Location: Cypress Infants and Junior, Informal Crossing, Auckland Road, Upper Norwood, Croydon.

Project: School Crossing Patrol

Stage 1 Road Safety Audit

Date: July 2025

PROBLEM LOCATION PLAN

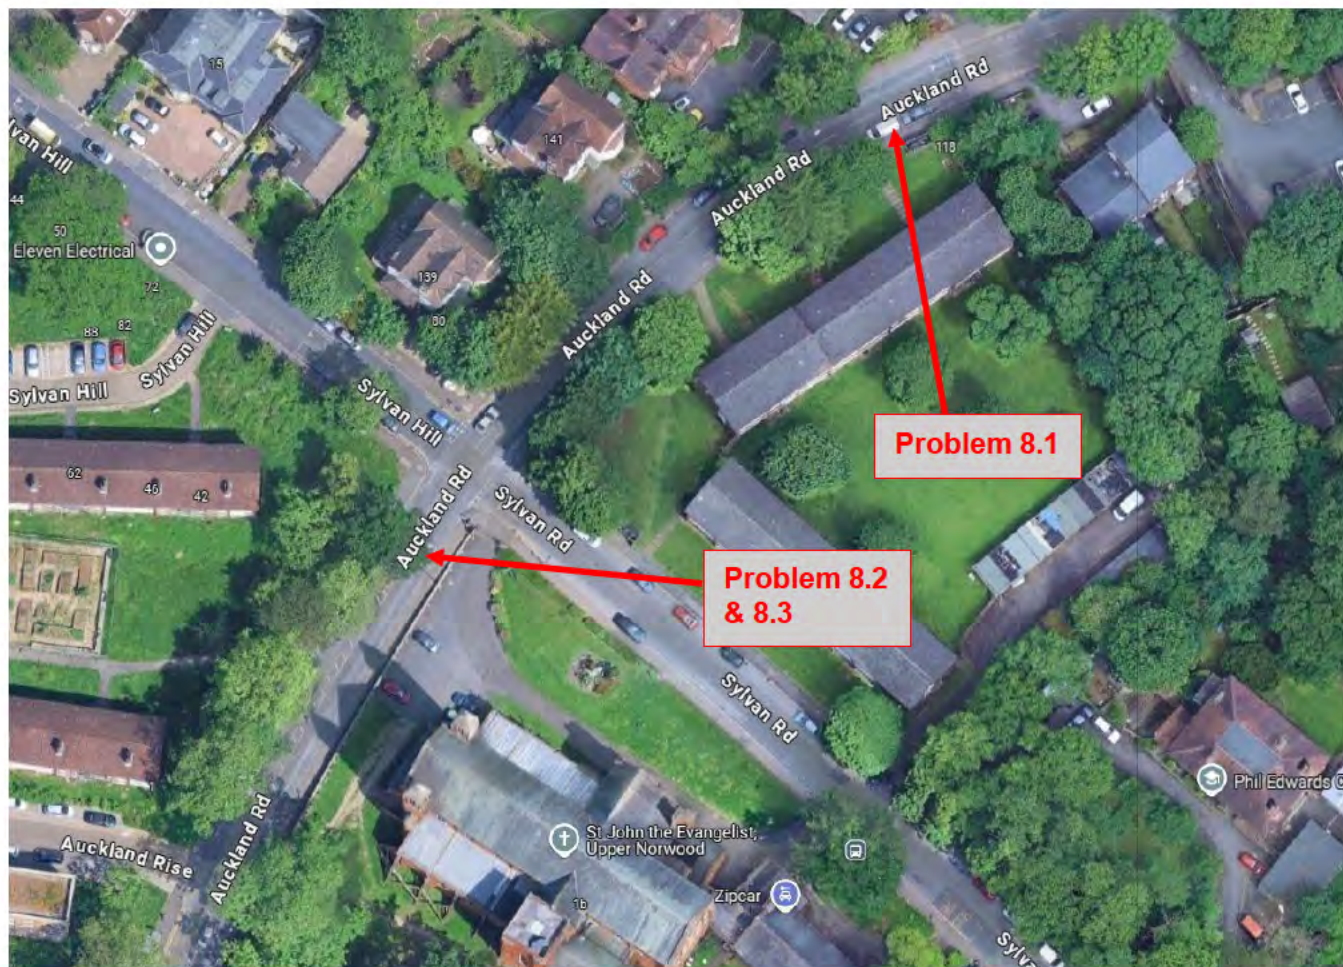
Existing centre island where
RSA was undertaken
